Pentium[®] II Processor Specification Update

Release Date: August 1998

Order Number: 243337-017

Figure 1. UP Dual Ended Termination (DET)

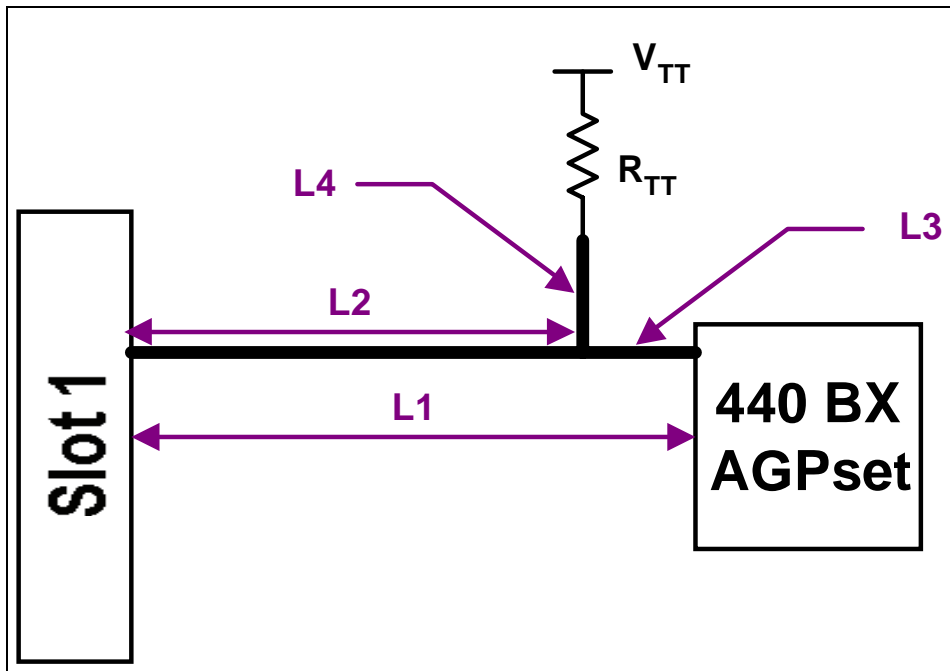
For UP-DET topologies (see Figure 1), the trace length L1 must be between 1.5" to 4.5" while using a 56Ω termination resistor.

Figure 2. DP Dual Ended Termination (DET)

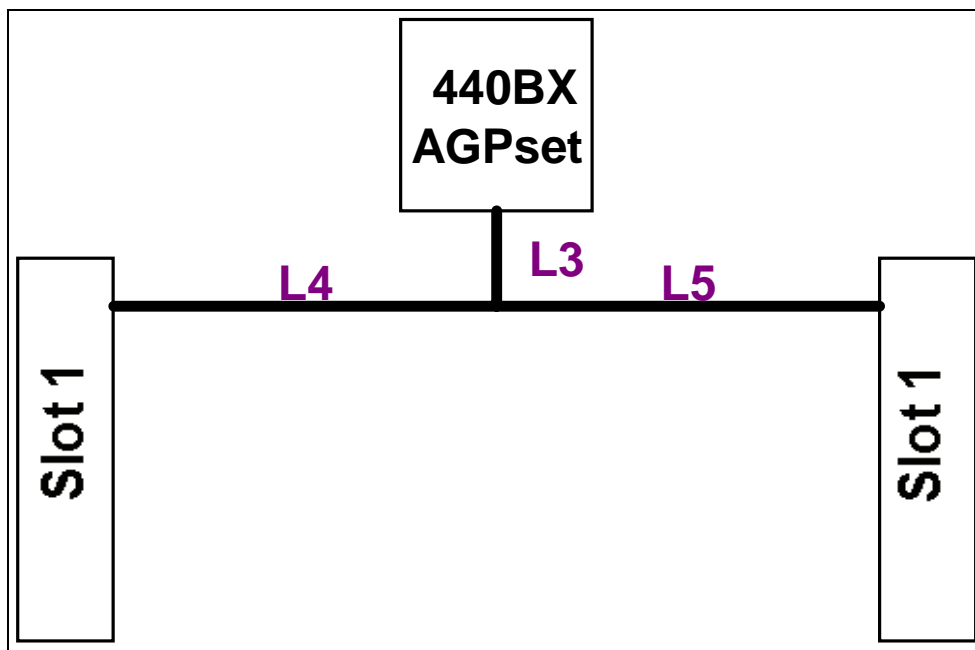
For DP topologies (see Figure 2) installed with a processor and a termination card, L4 + L3 or L5 + L3 must be less than or equal to 4.5". Additionally, for DP platforms with one processor installed, the termination card should be placed in the longer leg.

Figure 23. Processor with an Example Low Profile Heatsink Attached using Spring Clips

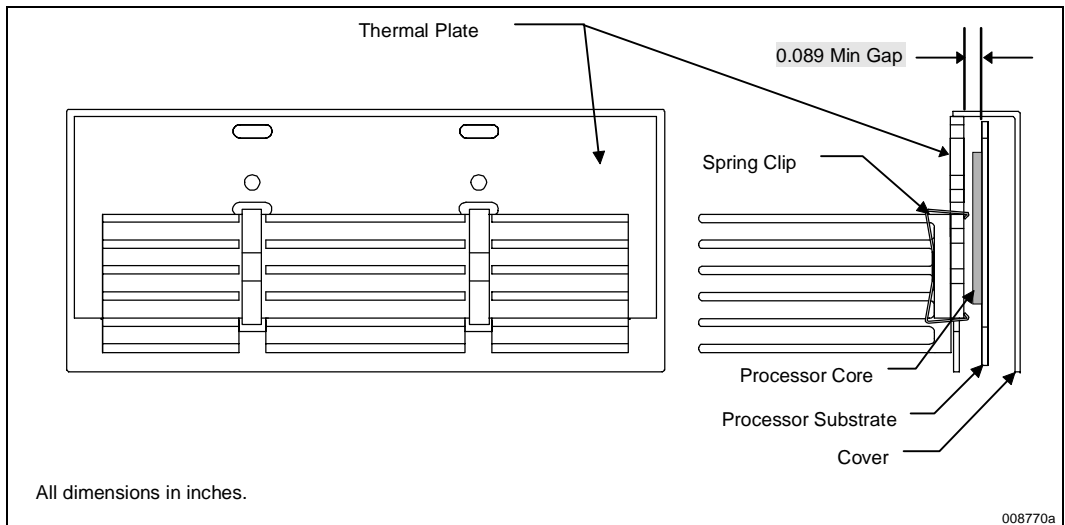
Figure 23 and Figure 24 illustrate example clip designs to support a low profile and a full height heatsink, respectively. The clips attach the heatsink by engaging with the underside of the thermal plate. The clearance of the thermal plate to the internal processor substrate is a minimum **0.089"** (illustrated in Figure 23 and Figure 24). The clips should be designed such that they will engage within this space, and also not damage the substrate upon insertion or removal. Finally, the clips should be able to retain the heatsink onto the thermal plate through a system level mechanical shock and vibration test. The clips should also apply a high enough force to spread the interface material for the spot size selected.

Figure 26. Heatsink Rivscrew* and Thermal Plate Recommendations and Guidelines

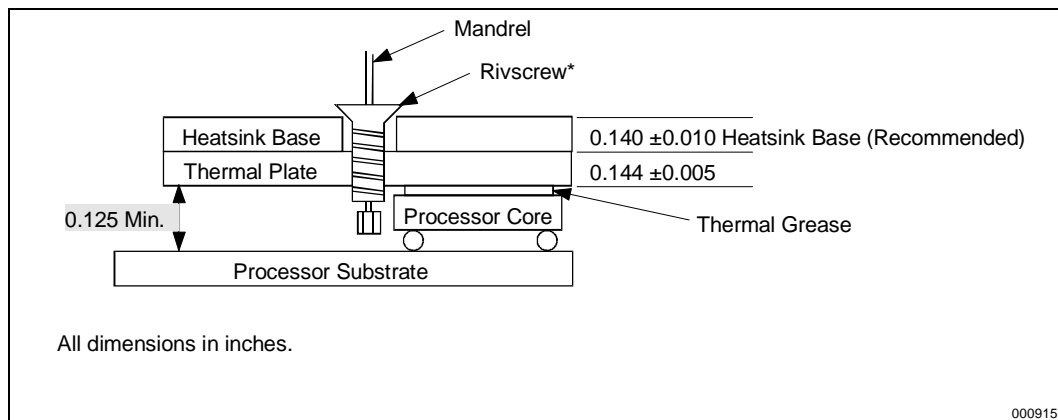
The Rivscrew attach mechanism uses a specialized rivet that is inserted through a hole in the heatsink into the thermal plate. Upon insertion, a threaded fastener is formed that can be removed if necessary. For Rivscrew attachment, the minimum gap between the thermal plate and the processor substrate is **0.125"**. For use of the Advell Rivscrew (part number 1712-3510), the heatsink base thickness must be $0.140 \pm 0.010"$. See Figure 25, Figure 26 and Figure 27 for details of heatsink requirements for use with Rivscrews.
